**TOWN OF WINTER PARK
PLANNING COMMISSION
Tuesday, July 14, 2020 8:00 AM
Online Meeting (instructions below)**

TO Planning Commission
FROM Hugh Bell, Planner
THRU James Shockey, Community Development Director
DATE July 14, 2020
RE Preliminary Plat Continuance – The Reserve at Lakota Park Subdivision

LAKOTA RESERVE AND NORTHWOODS @ LAKOTA WINTER PARK, COLORADO GRADING AND EROSION CONTROL PLAN

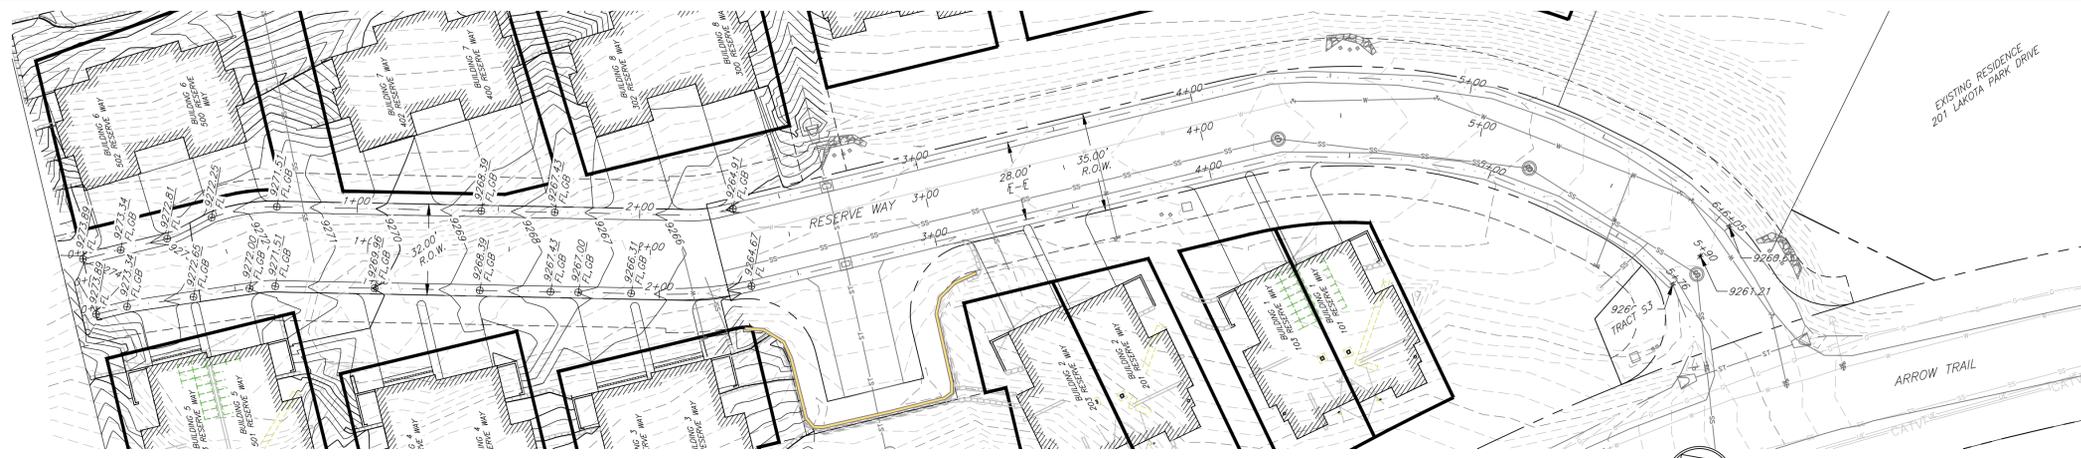
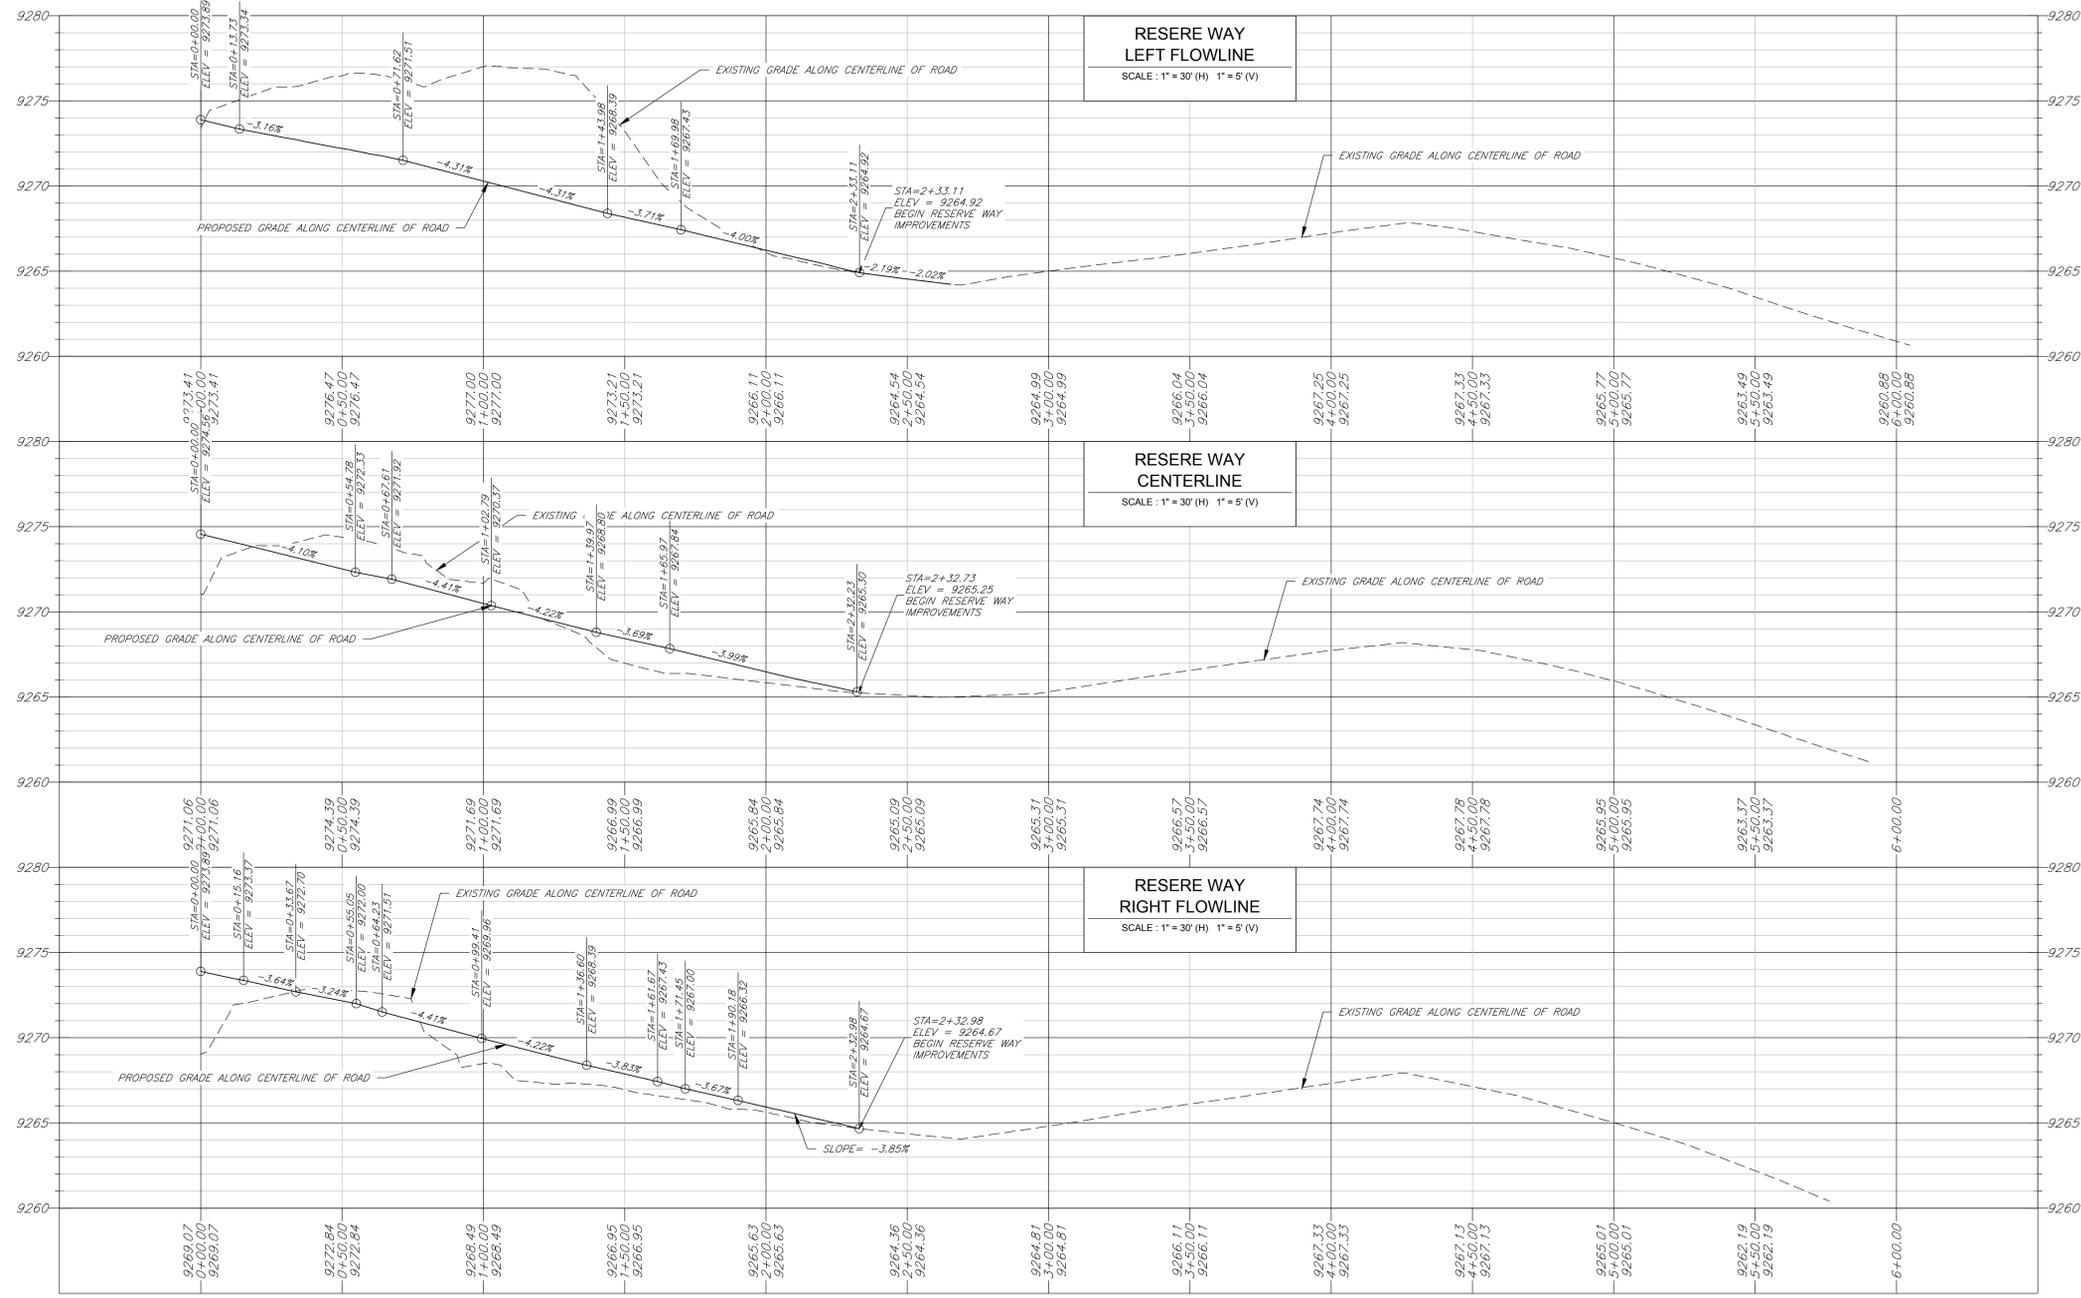
The Grading and Erosion Plan, Sheet 8 of Exhibit B, shows final cut slopes behind Building 7 and 8 (Lots 7 through 10) ranging between 1.4H:1V to 1.1H:1V. Denver Water is concerned that these final slopes are not stable long term. Exhibit C of the submittal contains the Geotechnical Engineering Study which contains similar geotechnical studies for each separate building. Under the section "Permanent Cut and Fill Slopes" all the reports state "*Permanent unretained cuts in the overburden soils should be constructed at a 3H:1V or flatter inclination.*" Under the Proposed Construction section, the reports also state "*the finished grade on the sides of the residence are proposed to have slopes lightly steeper than 2H:1V. A grade separation solution will be required at the sides of the duplex to achieve a less steep grade for slope stability purposes.*"

LAKOTA RESERVE AND NORTHWOODS @ LAKOTA WINTER PARK, COLORADO GRADING AND EROSION CONTROL PLAN

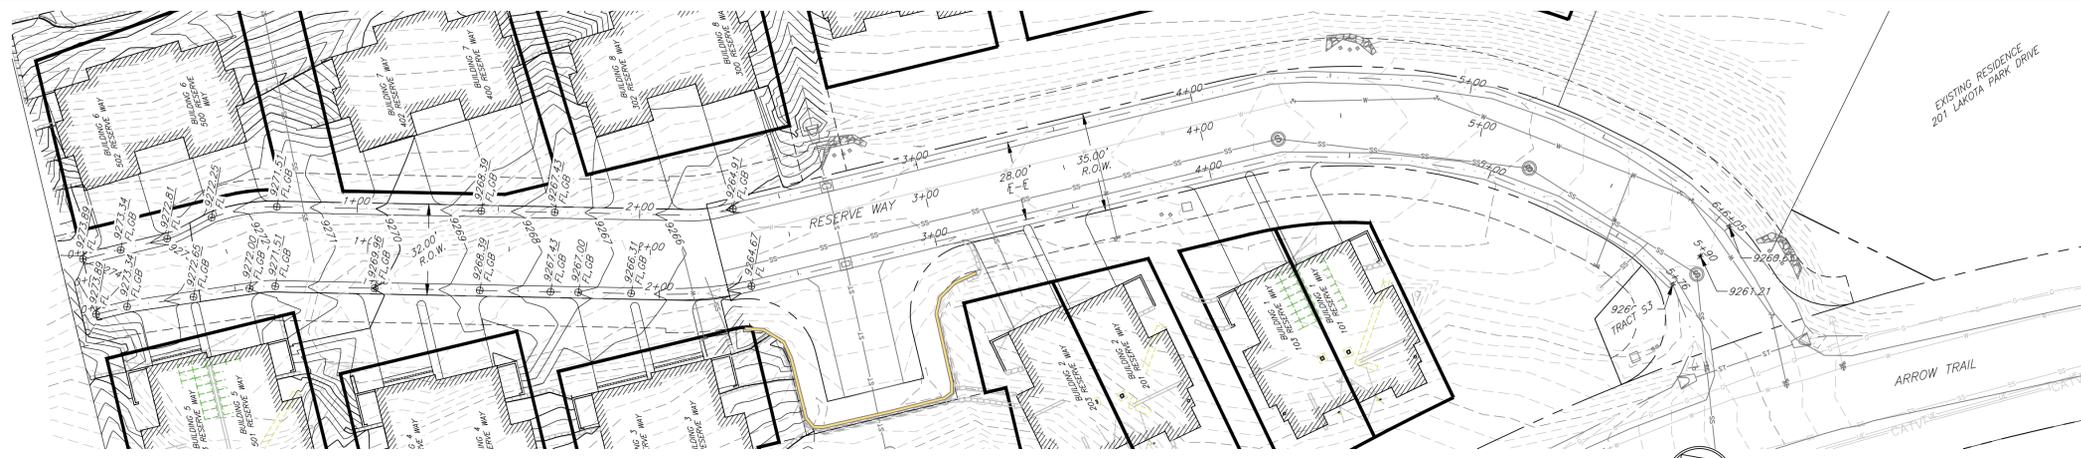
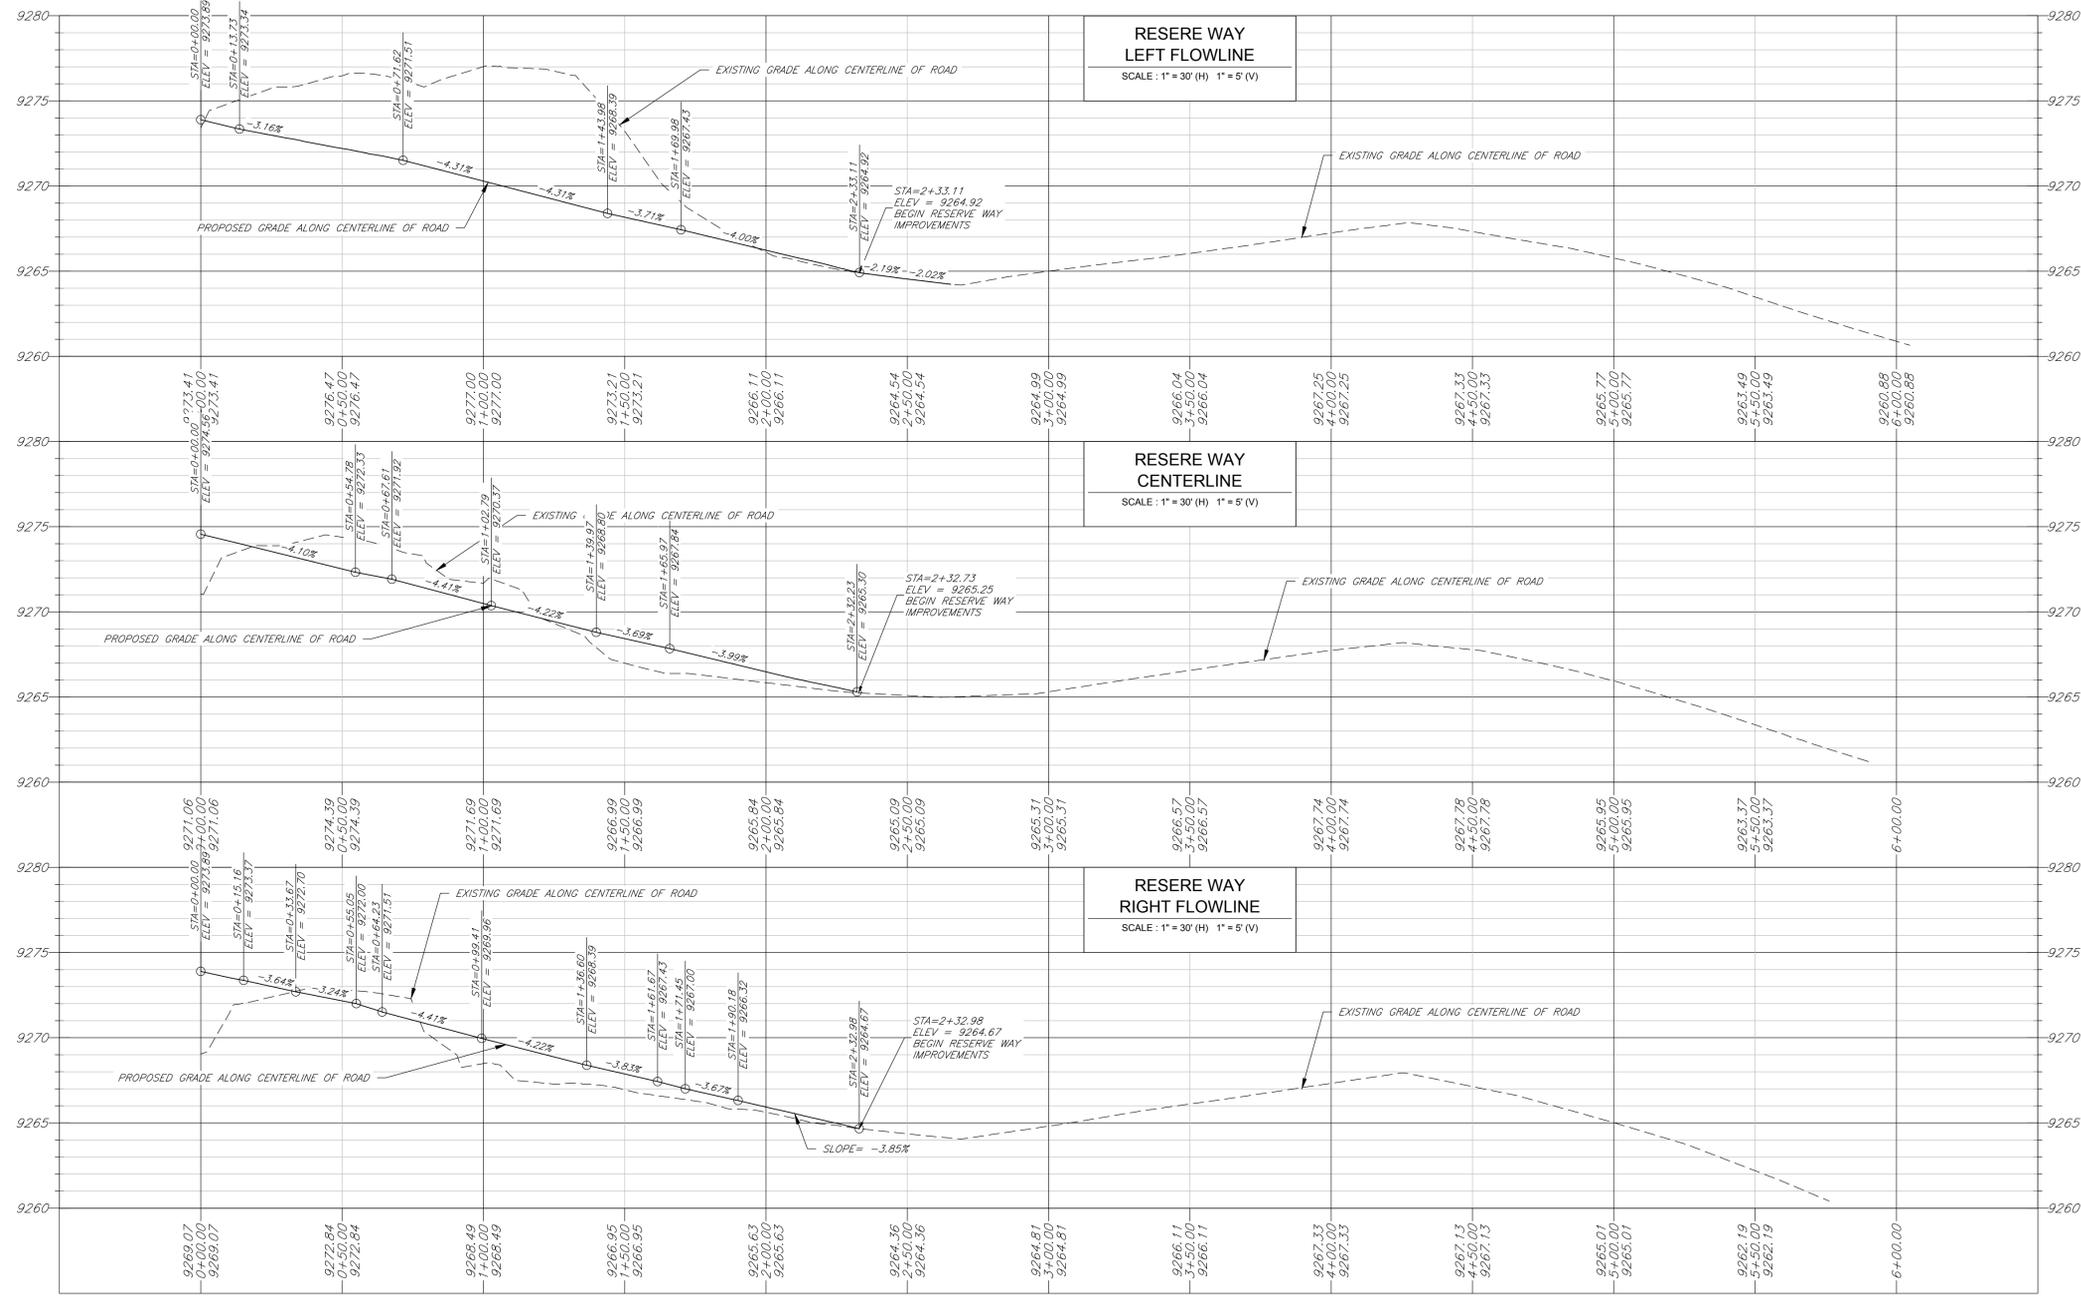
The Grading and Erosion Plan, Sheet 8 of Exhibit B, shows final cut slopes behind Building 7 and 8 (Lots 7 through 10) ranging between 1.4H:1V to 1.1H:1V. Denver Water is concerned that these final slopes are not stable long term. Exhibit C of the submittal contains the Geotechnical Engineering Study which contains similar geotechnical studies for each separate building. Under the section "Permanent Cut and Fill Slopes" all the reports state "*Permanent unretained cuts in the overburden soils should be constructed at a 3H:1V or flatter inclination.*" Under the Proposed Construction section, the reports also state "*the finished grade on the sides of the residence are proposed to have slopes lightly steeper than 2H:1V. A grade separation solution will be required at the sides of the duplex to achieve a less steep grade for slope stability purposes.*"
